Access Compliance Report Public Rights-of-Way (Curb Ramps)

Main Street: N/A Cross Street: SENDERO WAY Location: W

ADA ID: RPAT220208102502 Ramp Type: Type 6 - Directional 1 Initial Pass/Fail: Pass Overall Compliance: No Severity Score: 6

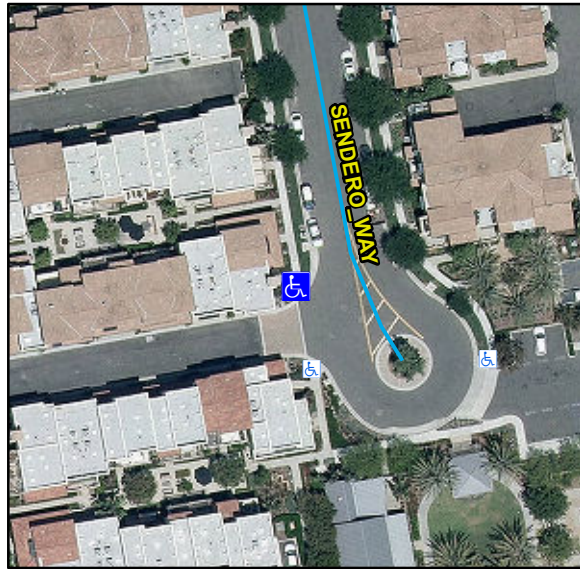
Remove & Replace Gutter.

R304.5.4, STD 1115
